- 7. Waterfront Tracts Resubdivision; KPB File 2023-104
Stantec Consulting Services, Inc. / City of Seward
Location: Railway Avenue & Lowell Point Road
City of Seward**

**ITEM #7 - PRELIMINARY PLAT
WATERFRONT TRACTS RESUBDIVISION**

KPB File No.	2023-104
Plat Committee Meeting:	November 13, 2023
Applicant / Owner:	City of Seward of Seward, Alaska
Surveyor:	John Brady / Stantec Consulting Services Inc
General Location:	City of Seward

STAFF REPORT

**WATERFRONT TRACTS
RESUBDIVISION**

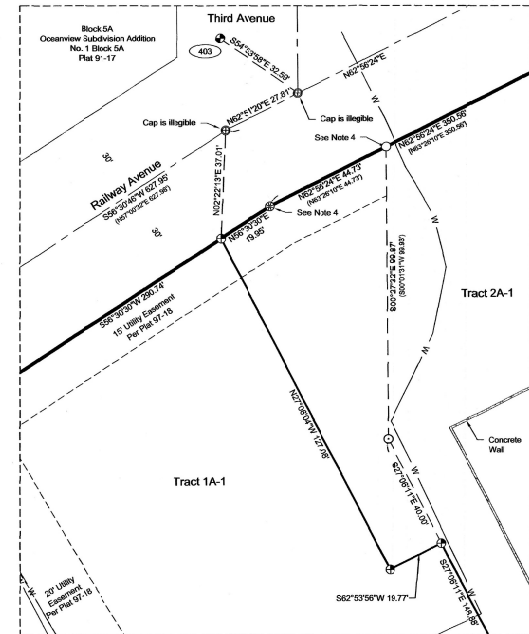
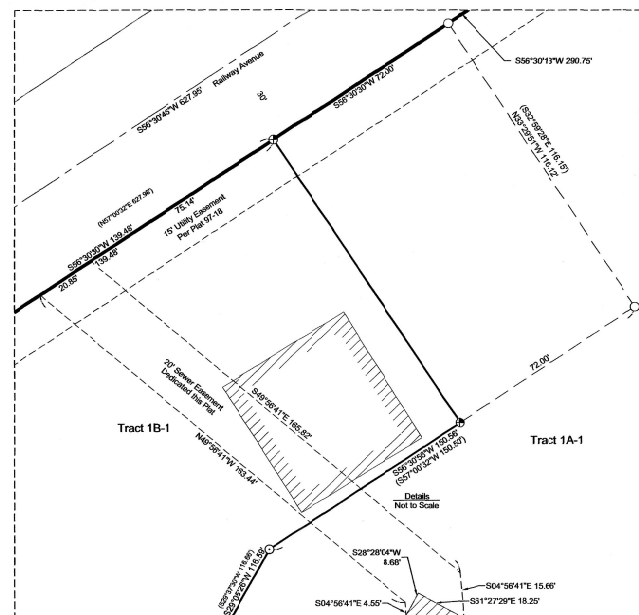
- Add KPB File no 2023-104.
- Please correct the entity information and code references within plat note 10. KPB is not the Floodplain authority within the City of Seward.
- On page 1, the measure bearing on the north line near Tract 1B-1 does not match the other bearings along the line at the seconds position.
- The 350.0# in Tract 2A-1 is different between pages.

WATERFRONT TRACTS RESUBDIVISION
 Creating Tract 1A-1, 1B-1 and 2A-1
 Containing ±14.51 Acres
 A Subdivision of:
WATERFRONT TRACTS MARCULTURE ADDITION, TRACTS 1A AND 1B PLAT 97-18 & WATERFRONT TRACTS, TRACT 2A PLAT 95-13

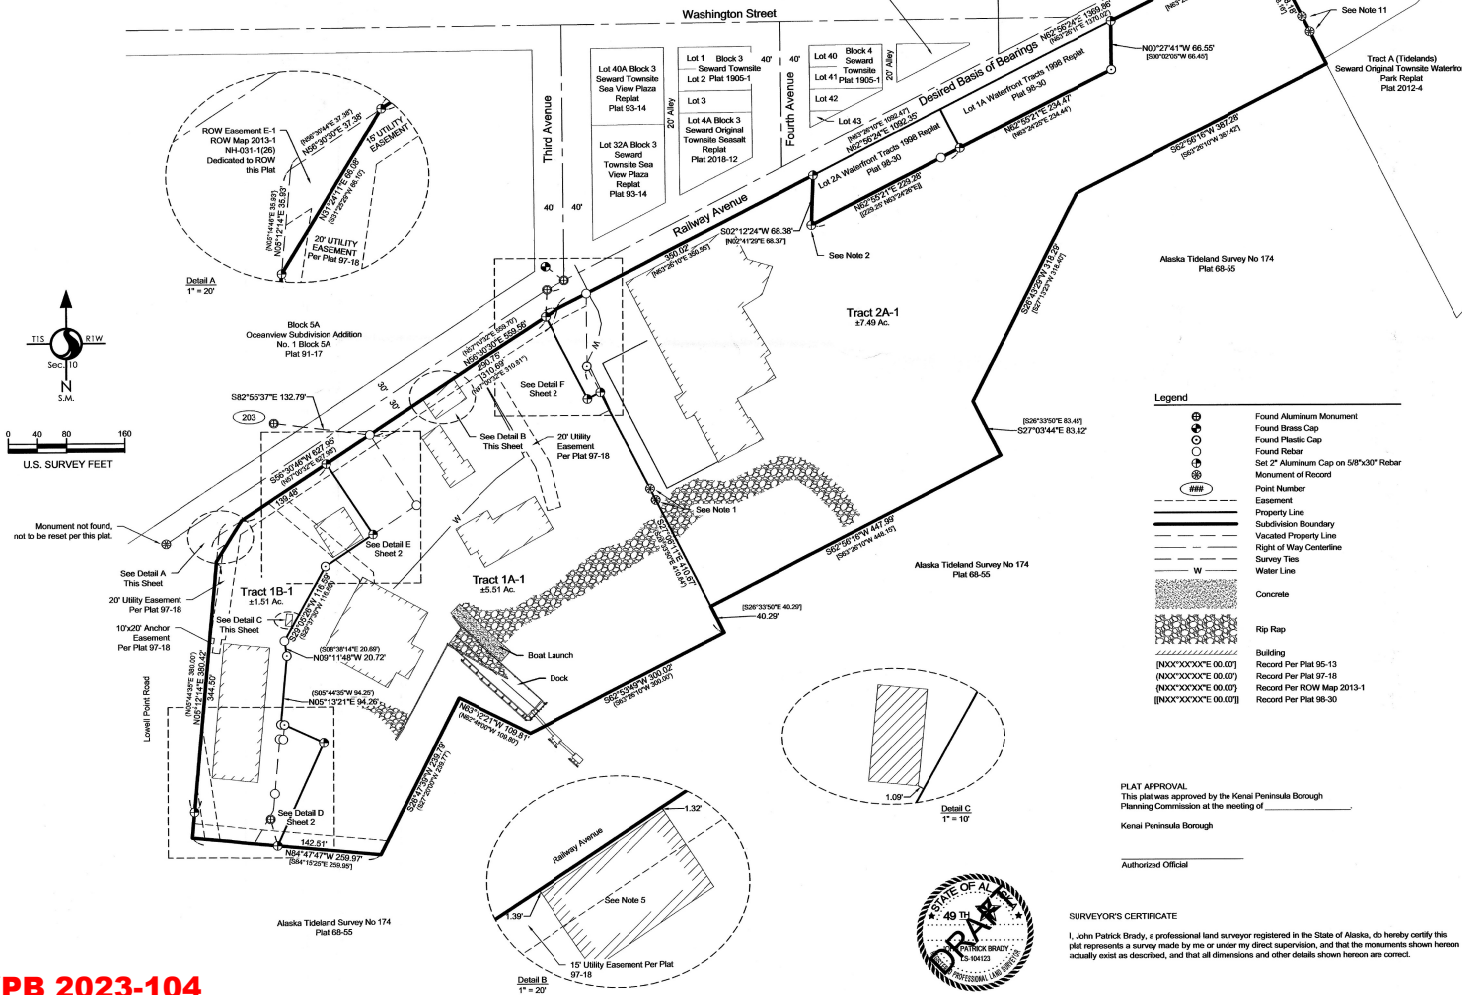
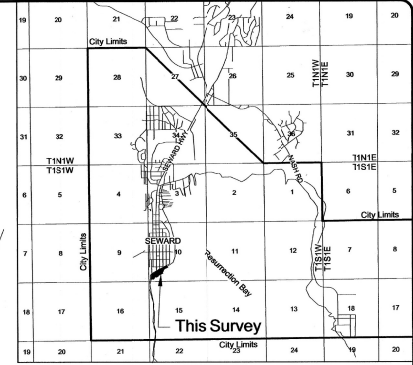
There will be a small portion of existing Tract 1B in the northwest corner of the subdivision being dedicated for right-of-way purposes. This dedication is shown in detail A in a larger view. ***Staff recommends:*** linework around the dedication be changed to show that it is included as part of the subdivision coming from Tract 1B.

- Staff recommendation:** Add City of Seward to the legal description. Add SW1/4 to the legal description.
- C. The location, width, and name of existing or platted streets and public ways, railroad rights-of-way, and other important features such as section lines or political subdivisions or municipal corporation boundaries abutting the subdivision;

- Staff recommendation:** Please add width labels for Railway Avenue on the northeast end for clarity. Add width labels for Washington Street, Lowell Point Road, and Ballaine Boulevard.

- Staff recommendation:** Reduce the shown area as to better identify the subdivision. If any part of the Chugach Forest is shown please provide a label. Add north arrow to map

- Staff recommendation:**
- Identify former lot lines on the drawing and details.
 - Right-of-way for dedication is part of subdivision and should be included in dark linework.

- *The borough will not enforce private covenants, easements, or deed restrictions per KPB 20.60.170.*
- *All development must comply with the municipal zoning requirements.*
- *On plat note two, remove the last sentence.*
- *At the end of plat note five add (see Detail B).*
